SERVICE BULLETIN

APPLICABILITY: All Models
SUBJECT: Tire Rotation Pattern

NUMBER: 05-37-07
DATE: 03/12/07

Tire Rotation Pattern for Non-Directional Tires

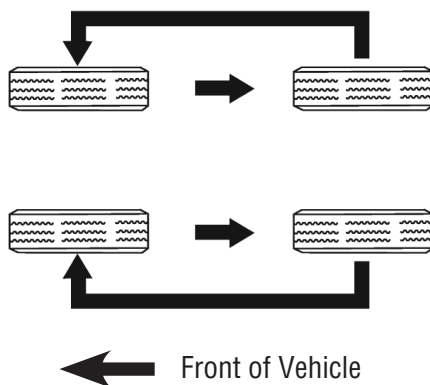
In an effort to further reduce uneven tire wear and prolong tire life, the tire rotation pattern has been changed for non-directional tires. To maximize the life of each tire and ensure that the tires wear uniformly, it is best to rotate the tires every 7,500 miles (12,000 km). Note: The tire rotation pattern for directional tires has not changed.
